# Geology and Geological Structure of Tsuruga Power Station Site

## D-1 shatter zone (summary)

Aug.01, 2013

The Japan Atomic Power Company

# Geological plan of D-1 trench

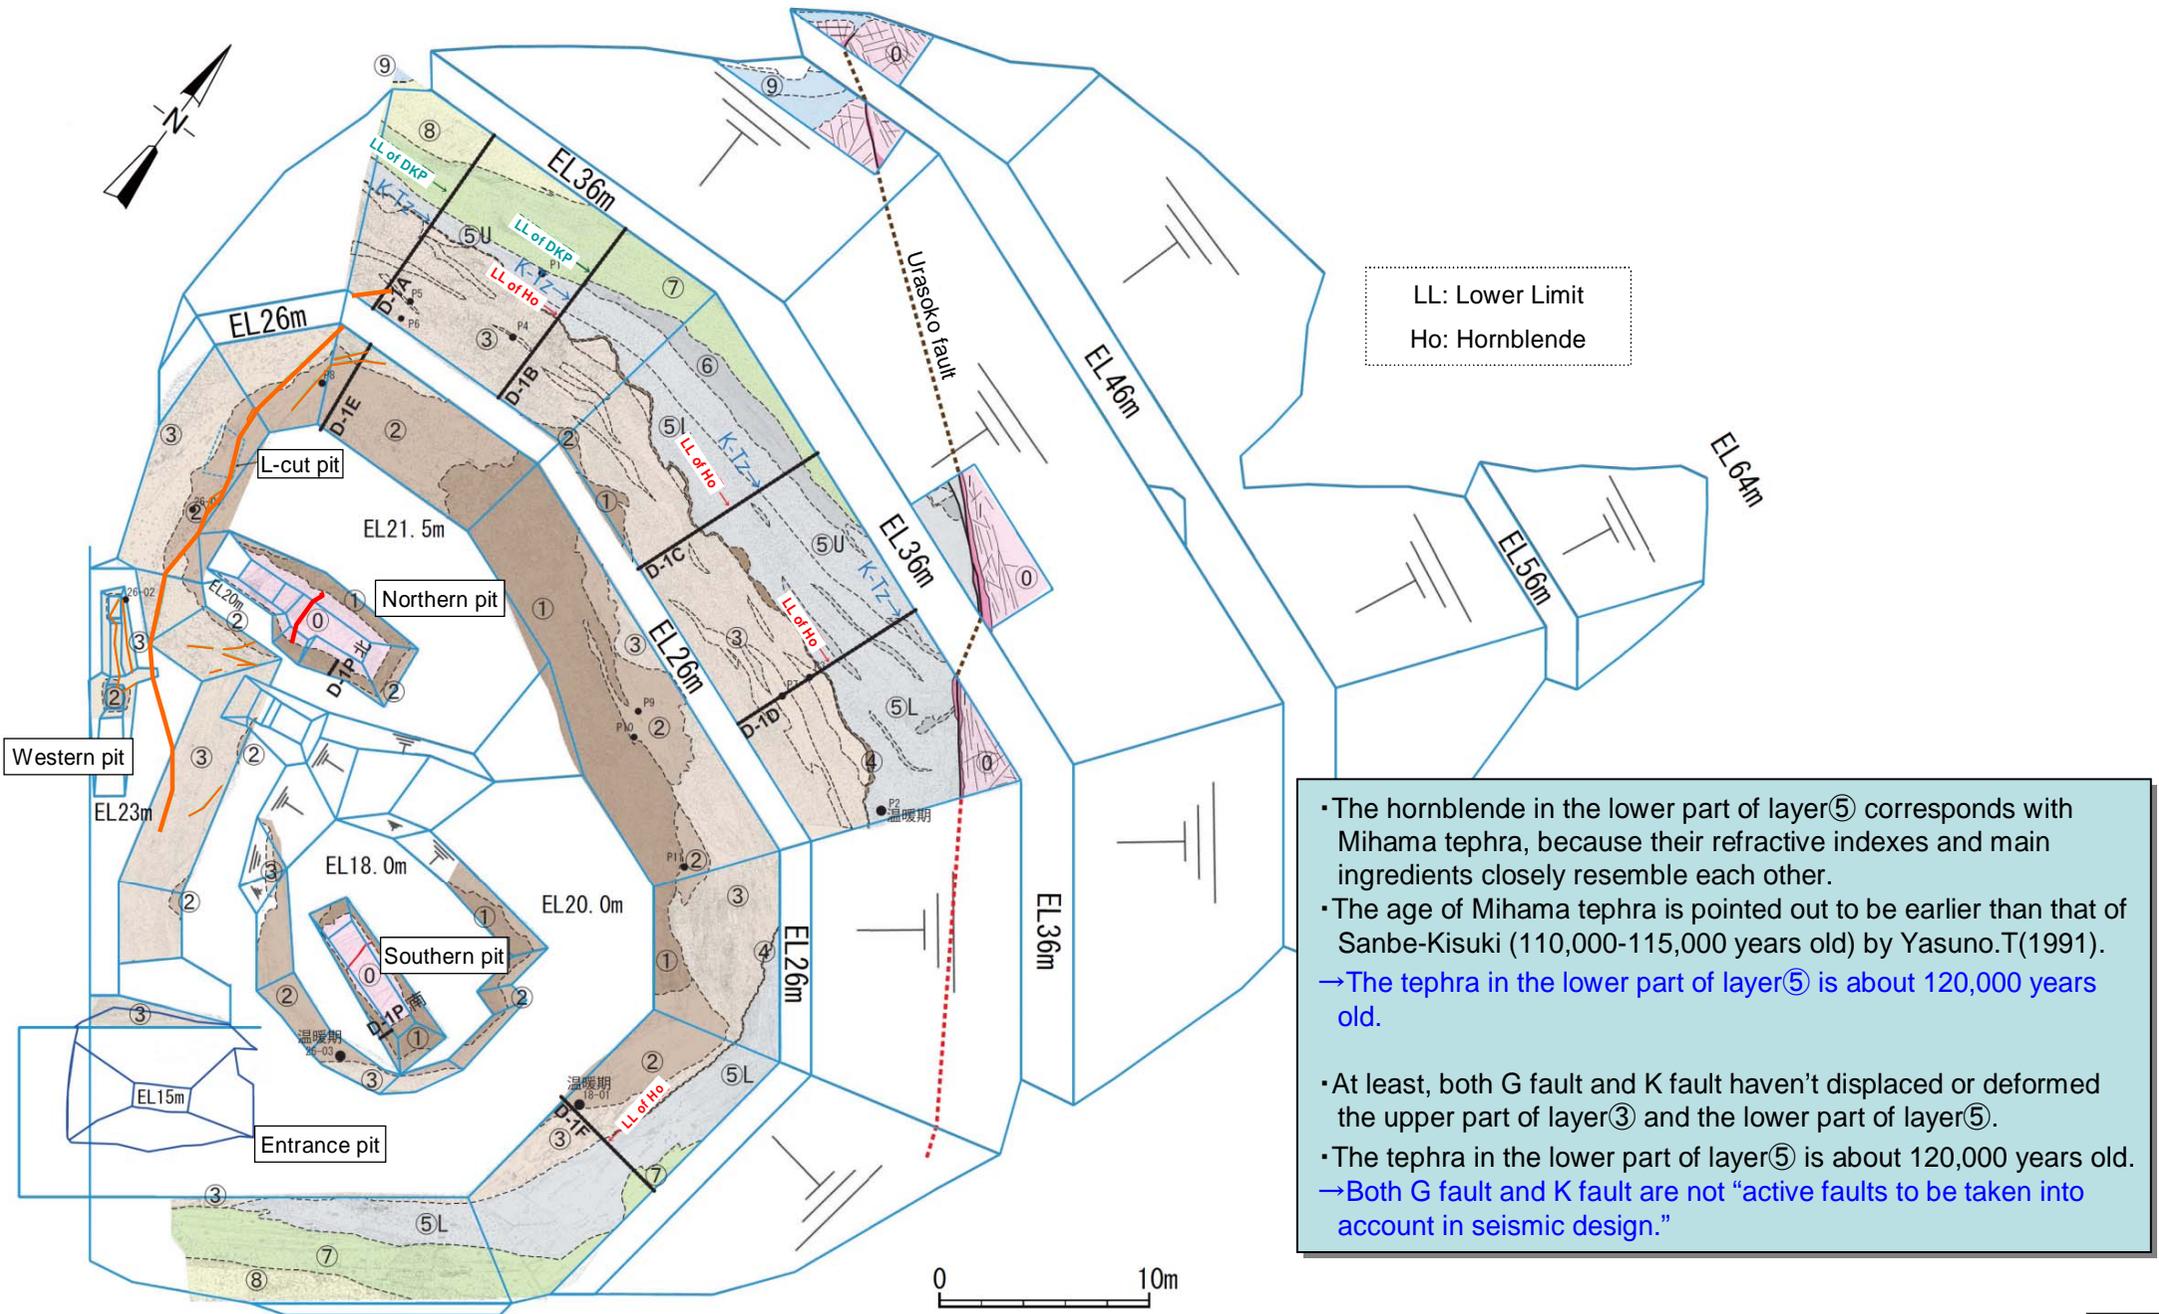
- Regarding the tephra in the lower part of layer⑤ both “identification of its horizon” and “identification of it” are insufficient.
    - Certification of tephra horizon : content rate of hornblendes is low frequency (under 1 count par 3000 counts).
    - Identification of volcanic ashes : source volcano, stratigraphic sequence, and formulation age are not fixed.
- It is difficult to identify the lower part of layer⑤ as a layer of about 120,000 years ago.

- Age of tephra are getting younger toward the upper layers.
  - The tephra in the lower part of layer⑤ is broadly distributed in a lateral direction.
  - The tephra in the lower part of layer⑤ is not found in layer③
- The tephra in the lower part of layer⑤ can be identified as a tephra horizon because it is deposited in an orderly manner without a mixture of other layers.

- Mihama tephra and various other tephras are compared each other by using analysis data of them.
- The age of Mihama tephra is identified to be about 127,000 years ago.
- Mihama tephra is identified to have fallen in a wide area.

## ② Activity period of the fault found in D-1 trench (K fault and G fault)

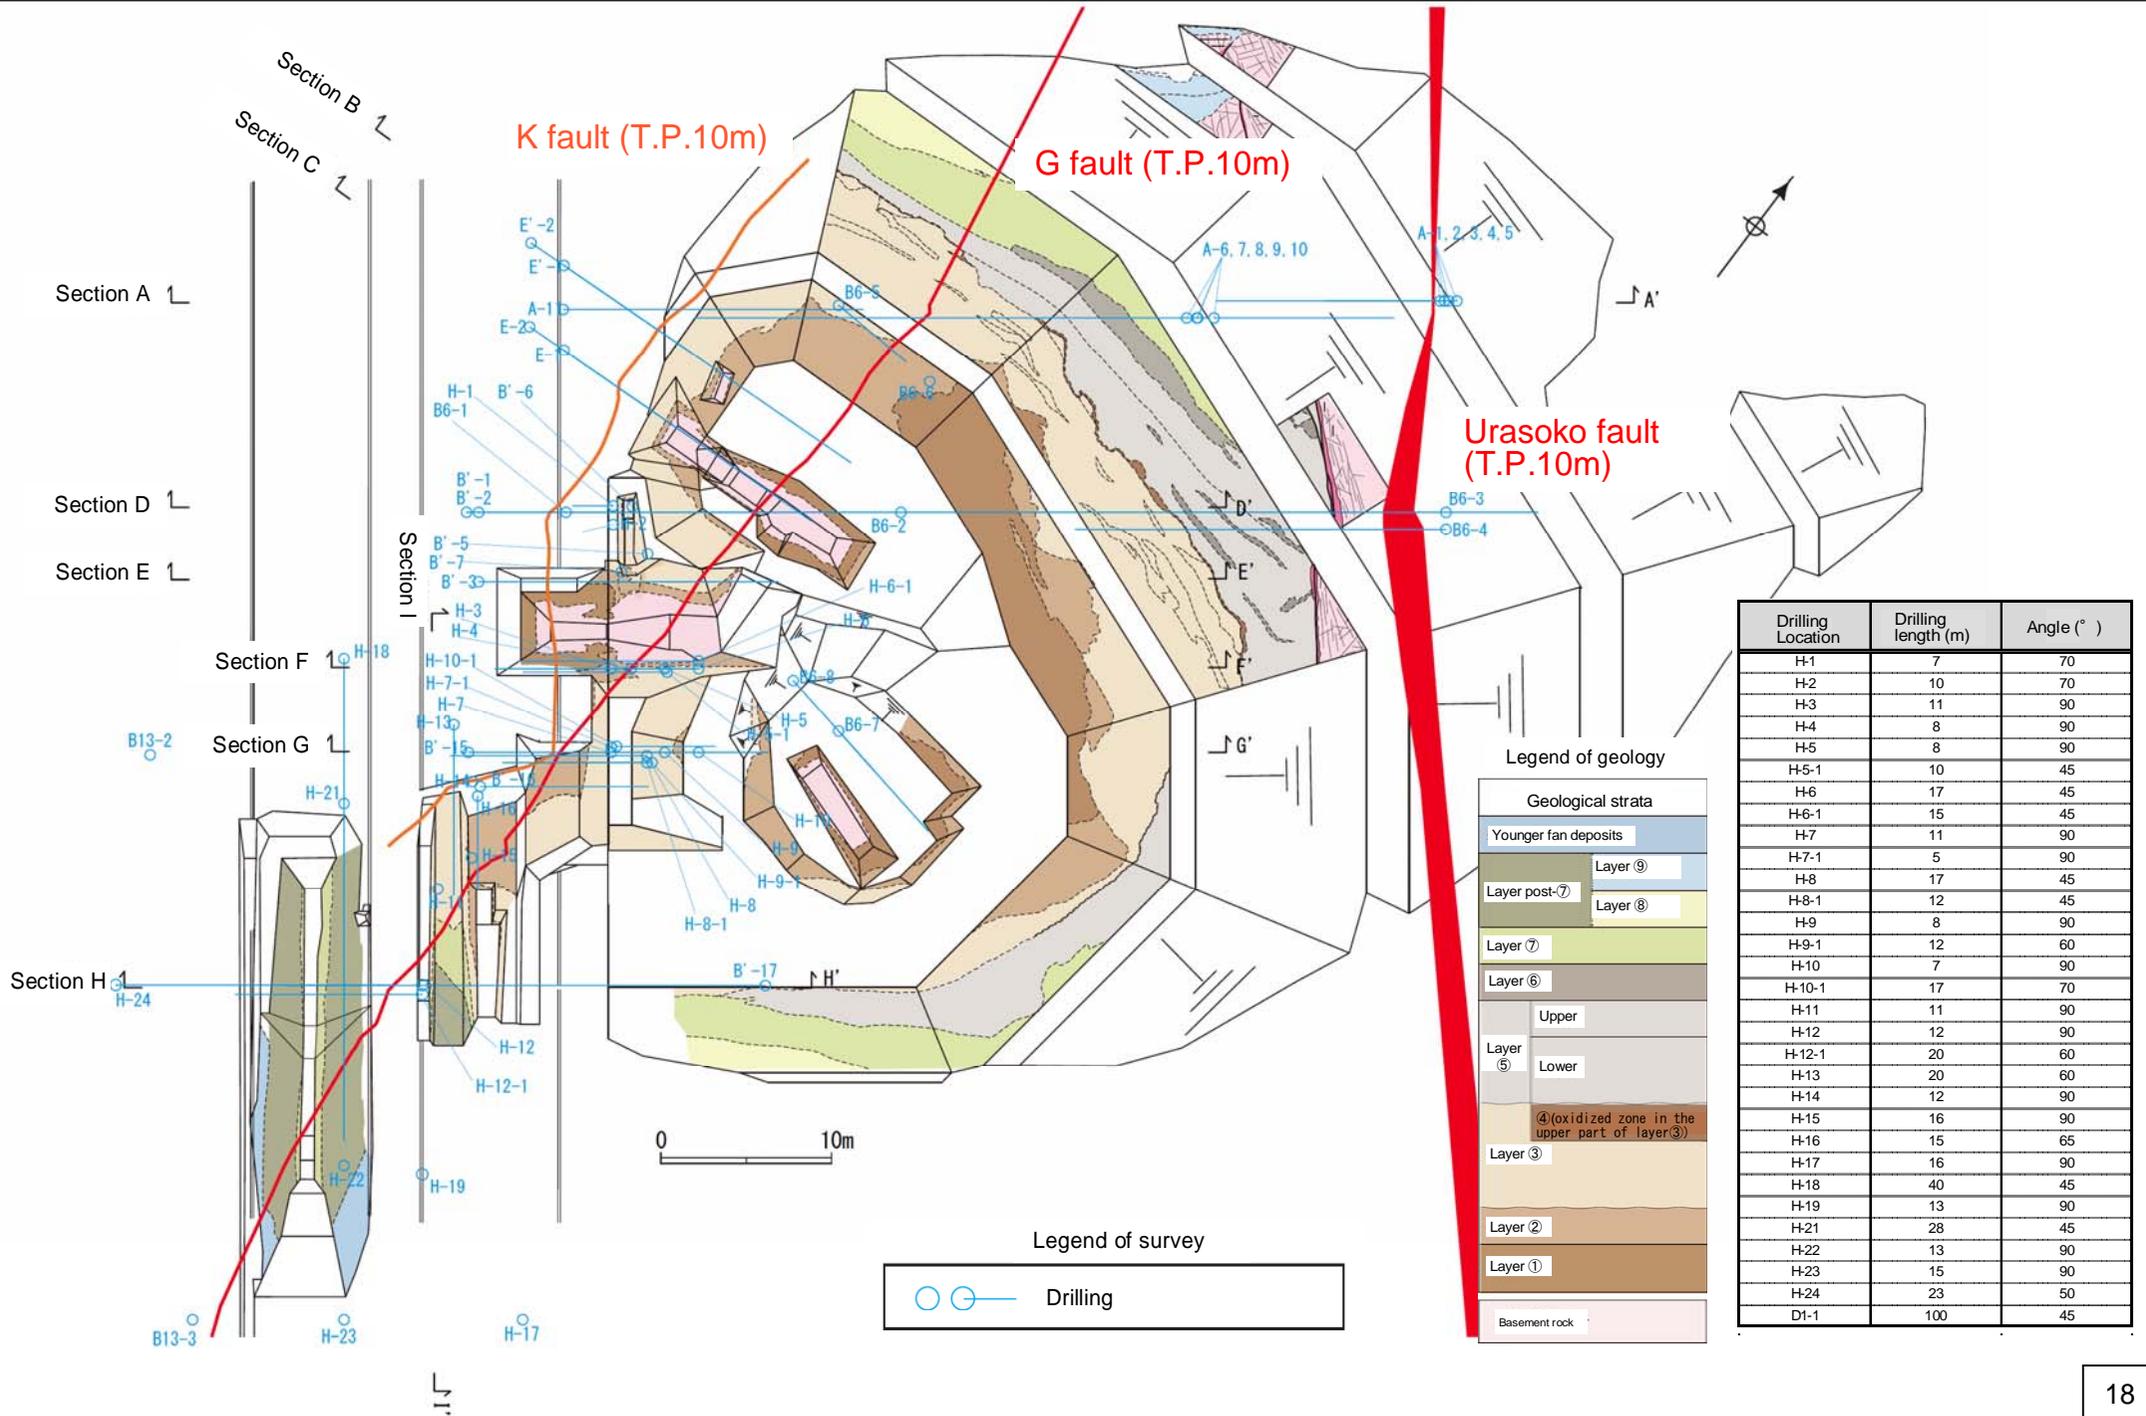
- Evaluation of the sedimentation period of layer⑤ is insufficient.
  - It could be considered that the sedimentation period of layer③ is not much earlier than that of layer⑤ and layer③ a relatively new layer because of the appearance of weathered gravels in it.
- K fault is an “active fault to be taken into account in the seismic design” because the possibility of it to have been active after the Late Pleistocene cannot be denied.

- The age of Mihama tephra, which corresponds to the tephra in the lower part of layer⑤, is about 127,000 years old.
  - The sedimentation period of layer③ is the Middle Pleistocene from the result of offshore drilling in Tsuruga Bay.
  - It is also confirmed that K fault has not displaced or deformed the upper part of layer③ in Genden road pit, though the activity of K fault has been evaluated in only one survey point (the northern wall of D-1 trench).
  - K fault has some characteristics: running along a serpentine course in the basement rock near D-1 trench, and decreasing its displacement sharply and disappearing in a quite narrow area.
- It is elucidated that K fault is not an “active fault to be taken into account in the seismic design.”

# Continuity between D-1 shatter zone, G fault and K fault

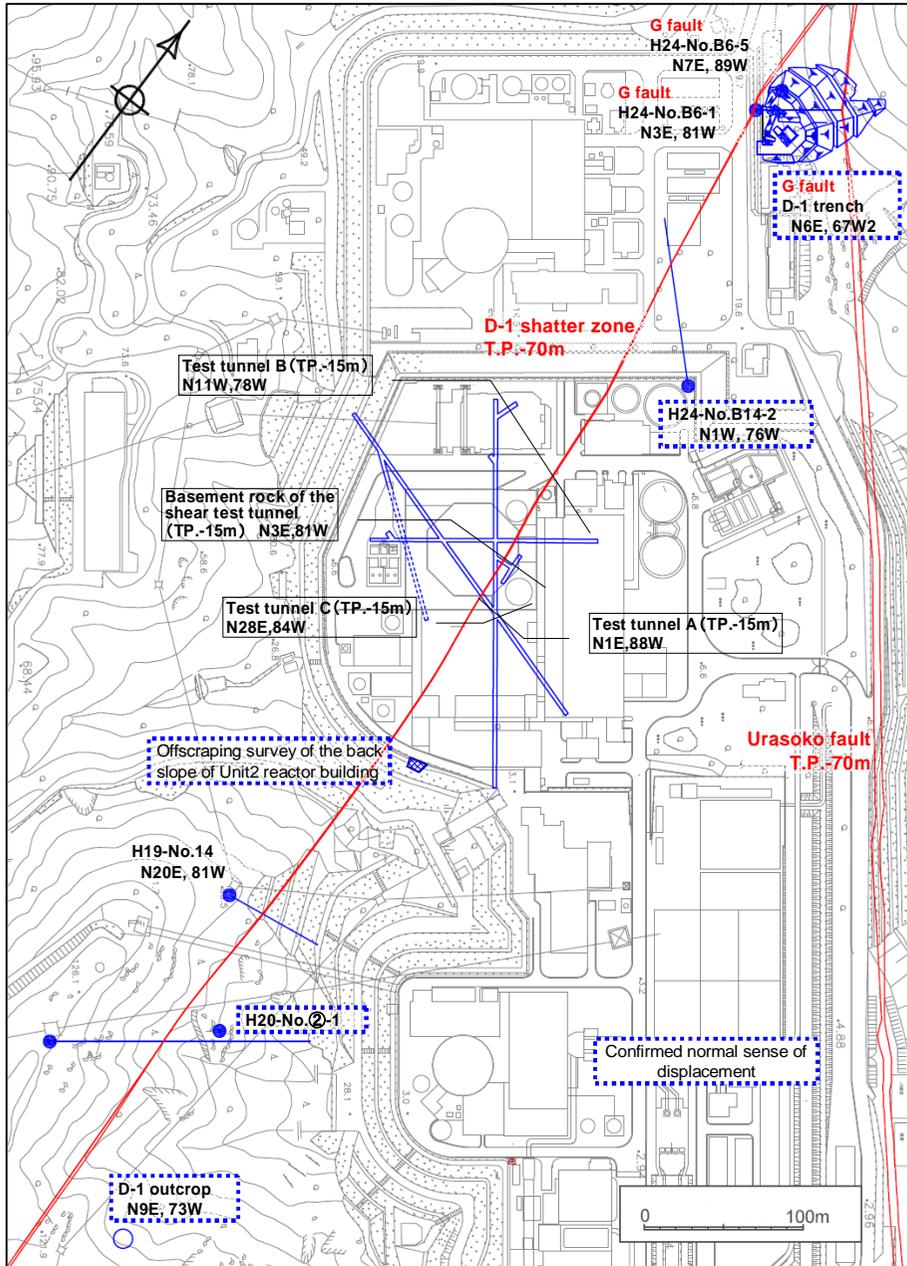
- It is likely that the JAPC has not appropriately identified the displacement sense of the last slip.  
→ It cannot be determined that the G fault and the D-1 shatter zone are identical.
- Both the G fault and the K fault are located near the extension of the D-1 shatter zone, and their shapes (strike and dips) are very similar to that of D-1 shatter zone.  
→ It is highly likely that G fault and K fault have continuous structure with D-1 shatter zone.

- Totally considering the continuity between D-1 shatter zone, G fault and K fault with additional viewpoints.  
(Viewpoints so far)  
“Strike and dip” and “Displacement sense of the last slip”  
(Additional viewpoints)  
“Structure of fault gouge”, “Color tone of fault gouge”, “Component minerals of fault gouge”, etc.  
→ It became much clear that the D-1 shatter zone continues to the G fault but not to the K fault.
